DESIGN EXCELLENCE COMPETITION JURY REPORT

City of Parramatta

Phase 2 Competition for Architectural Design
Block H, Precinct B, Wentworth Point
21 November, 2019

Image: FJMT response to Jury revised 54k and 85k tower forms

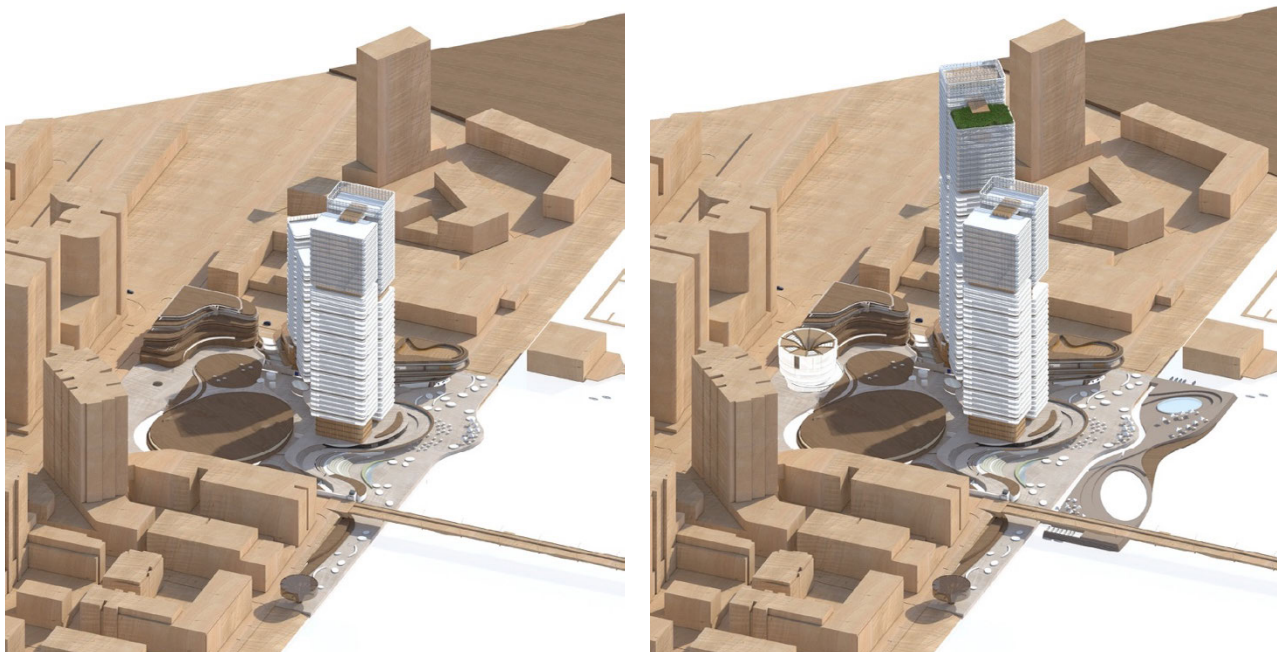
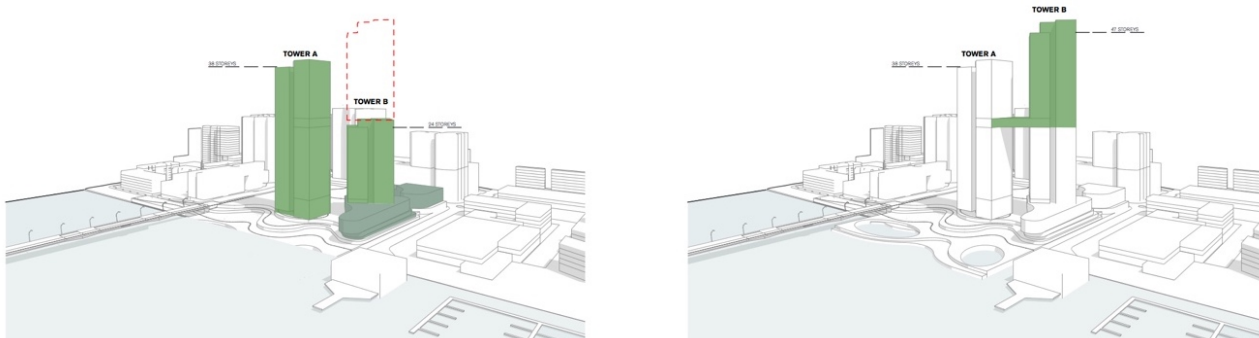
The Jury requested further information and design development to be undertaken by FJMT to assist them in their assessment of Design Excellence which is set out in the Preliminary Jury Comments at Appendix 1.

In responding to the Jury's preliminary comments, the design of the towers has been revised with altered orientations and approaches to articulation to reduce the perception of overall mass as well as introducing vehicle access into the park to the towers and replanning the foreshore building lines.

Diagrams showing Scenario 1 and 2 massing (FJMT)

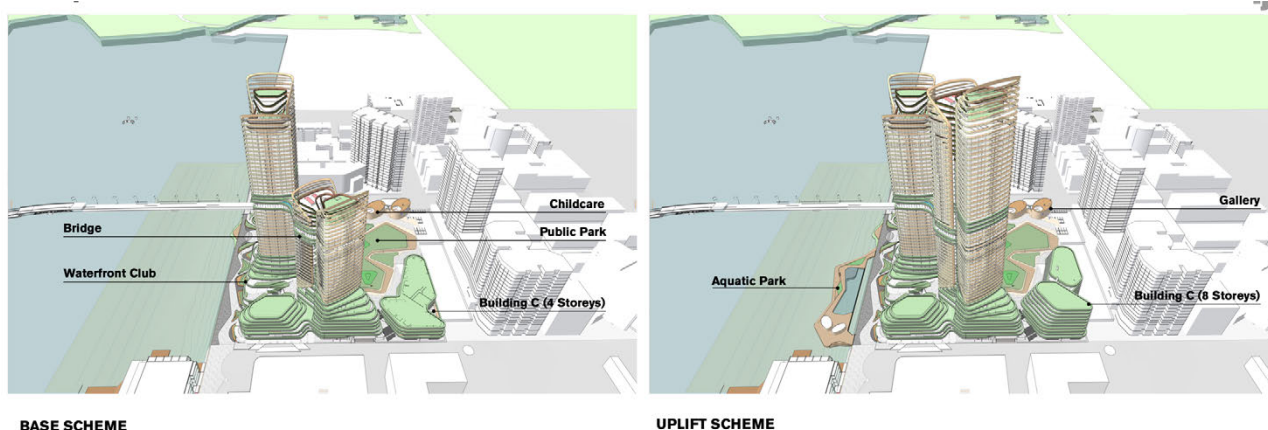
- The Jury requested that Council's independent ESD advisor review and comment on the draft submission.
- The key items that require design development are:
 - Natural Cross Ventilation remains unresolved and it is not clear how the ADG requirements will be met,
 - Adequate ventilation of enclosed balconies, and
 - Significantly challenged in achieving solar access compliance, particularly Tower A.

- Minimum ADG solar access and natural cross ventilation are achieved in the refined schemes, which are anticipated to achieve full Guide compliance.
- A more regular, “calmer” podium, has been reintroduced for a better urban outcome on Burroway Road and has been broken into three separate buildings to improve ADG environmental and amenity performance.
- A more measured exuberance is reflected in the schemes. The achievement of amenity, privacy, solar access and ADG compliance aspects of the “butterfly form” tower floorplates have been thoroughly considered and demonstrated in the revised schemes.

Draft plan extract showing revised low level floor plates with improved ADG compliance (FJMT)

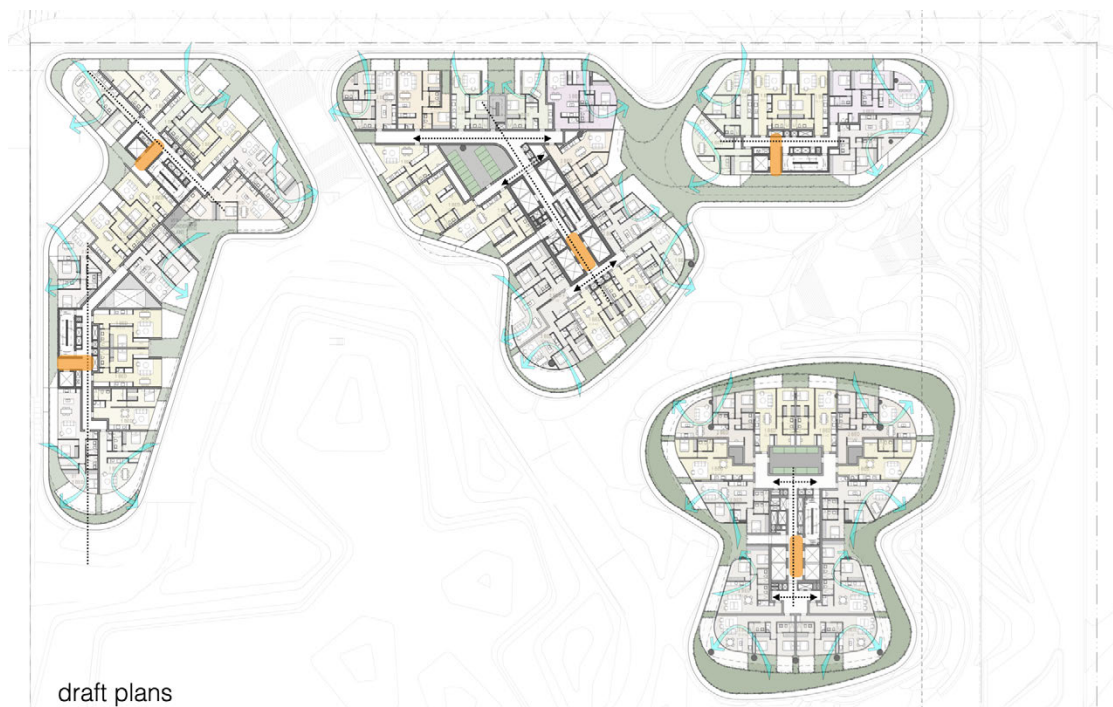
- The Jury are concerned that some key requirements of the ADG are not being achieved – including solar access and natural cross ventilation.
- In order to achieve Design Excellence, the Jury require that full compliance with the ADG is achieved. This requirement is considered acceptable based on the unconstrained size of this site, and the fact the design has been the product of a Design Excellence Master Plan Competition.

Extract showing soil depth provision (FJMT)

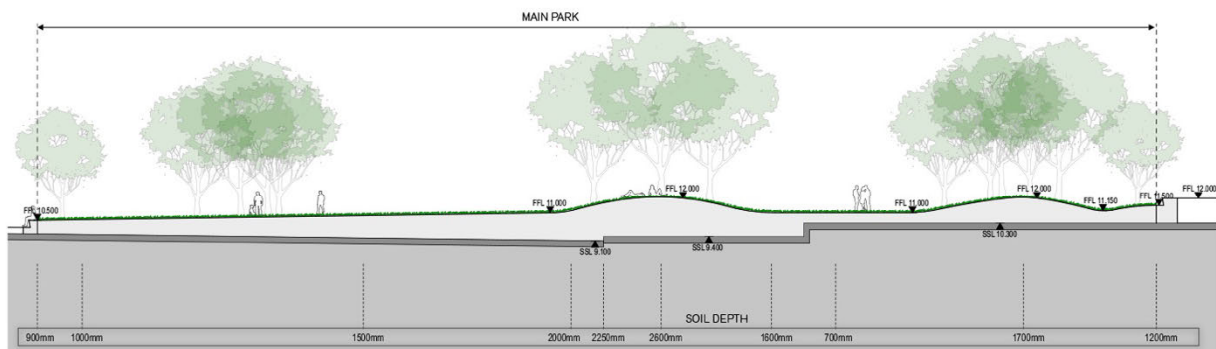
- The design development of the landscaping and shared way have been thoughtfully executed. The Jury are of the view that the landscape design is “heading in the right direction” and will be a positive outcome for the community.
- Council’s City Architect, on behalf of the Jury has requested that Council’s Public Domain team review the latest submission and attend all future Jury Presentations.
- The Jury would also like to better understand, in plan and section, how deep soil zones are achieved and the landscape vision is realised.

- Council's Public Domain team will be closely engaged through to DA submission while the adequacy of the soil depth zones to achieve the landscape vision have been provided in plan and section as extracted below.

Diagram showing traffic movement onto the site (FJMT)

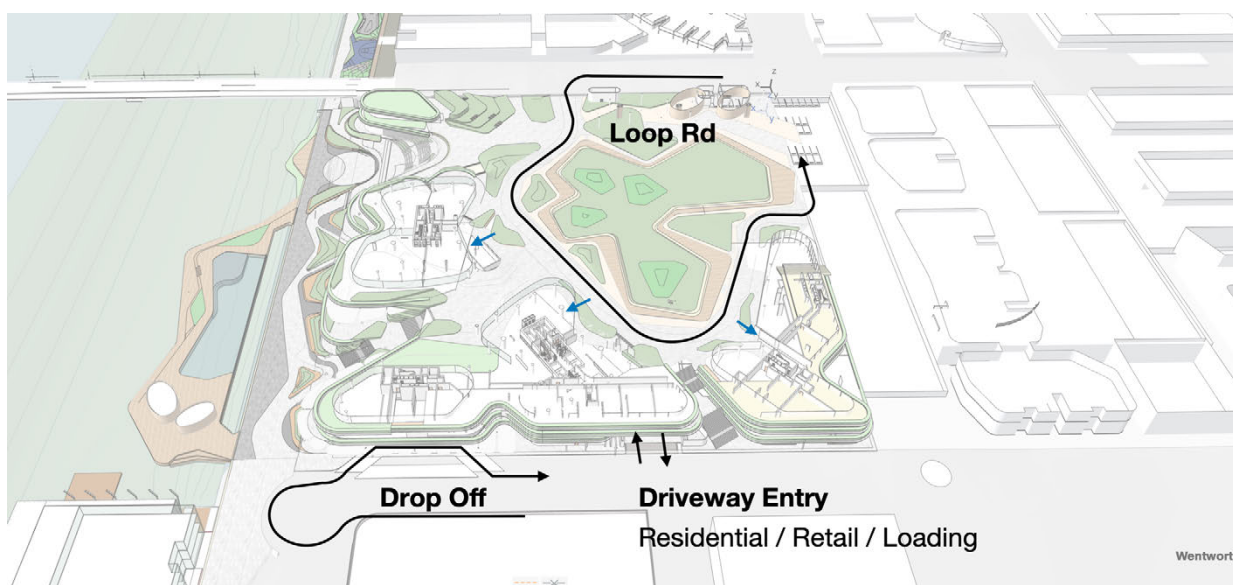
- The Jury would like to better understand how traffic works holistically across the site.
- The Jury question the removal of the “oculus” that provided light into the basement carparks. It is recommended that every effort is made to providing natural light and ventilation into the basement carparks.

- The “oculus” providing natural light and ventilation into the basement carparks has been re-established.
- Details as to how traffic works holistically across the site has been provided and summarised in the extract below.

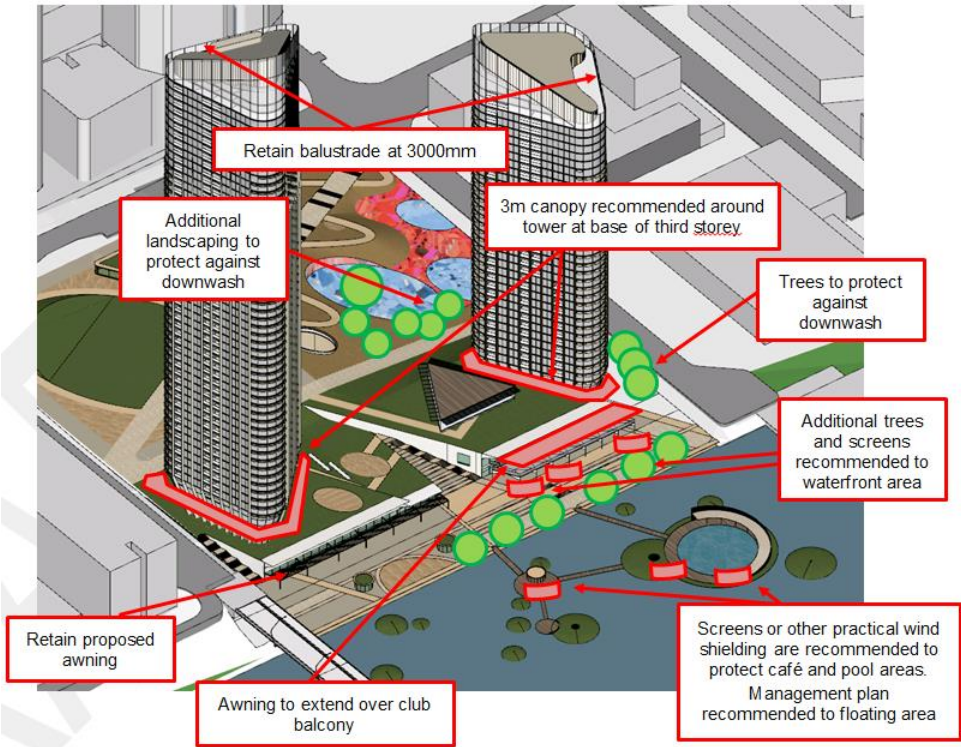
Waterfront Promenade: Landscaping and screens are recommended to protect seating and standing areas.

Floating Area: Screens or practical wind shielding is recommended to the area. A management plan regarding adverse winds and use of the public space is recommended to be applied to the floating area.

Club Balcony: Awning is recommended to be extended to protect seating and standing areas

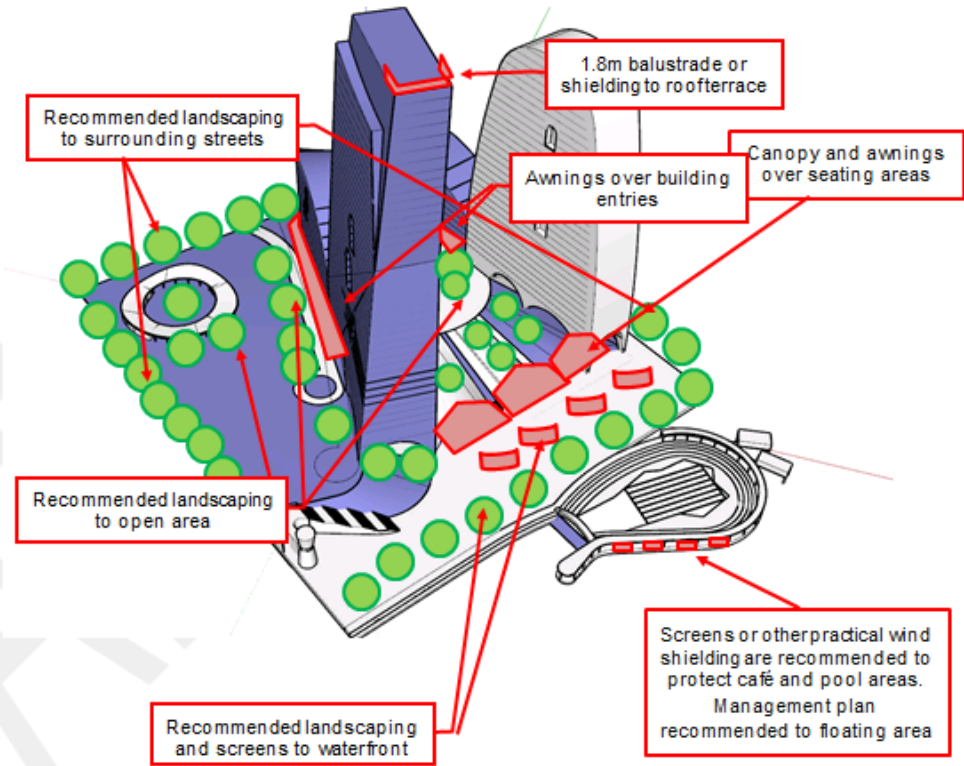
Upper Level Balconies: Corner balconies or balconies with dual aspects are recommended to incorporate vertical shielding elements, to ensure they have only one open aspect.

Level 40 Communal Terrace: Vertical shielding surrounding terrace eg balustrade is recommended to be set at 1800mm above floor level.

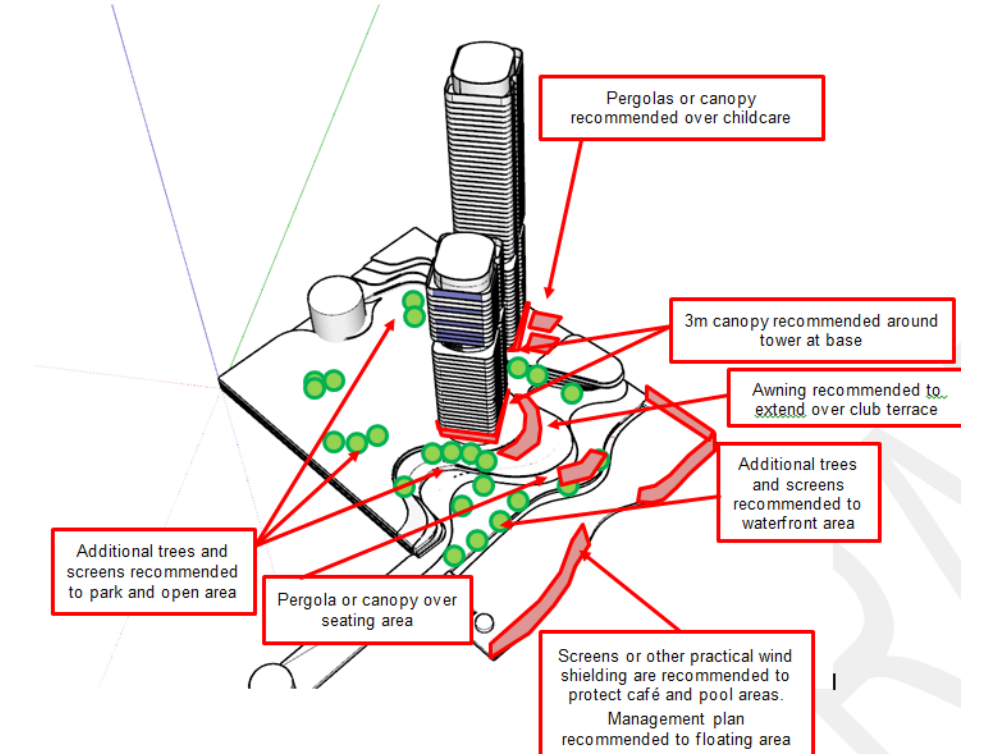
Floating Area: Screens or practical wind shielding is recommended to the area. A management plan regarding adverse winds and use of the public space is recommended to be applied to the floating area.

Club Terrace: Extend awning above or incorporate pergolas/ canopy to protect seating areas.

Tower Entries: A 3m canopy is Recommended to the surrounds of both towers to be applied as low as practically feasible. Alternatives to this could be assessed through quantitative testing during DA stage.
